SIB 12 01 21

## RECALL: CHECK 48 V CABLE CONNECTIONS ON STARTER GENERATOR (SGR)

This Service Information Bulletin (Revision 1) replaces SI B12 01 21 **dated February 2021**.

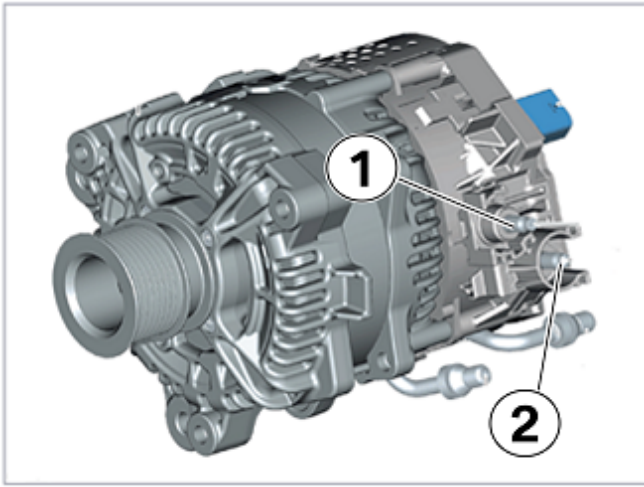
Check the positive (1) and negative (2) cables for play at the mounting lugs on the SGR.

If there is play in the connection to the SGR –

- Deactivate the 48 V electrical system (Repair instruction REP-TAT-P-6124-18-B47\_48V)
- Remove and discard the flange nut on the B+ or B- cable
- Install a new flange nut so that it's carefully started by hand to avoid cross-threading
- Torque to 19 Nm
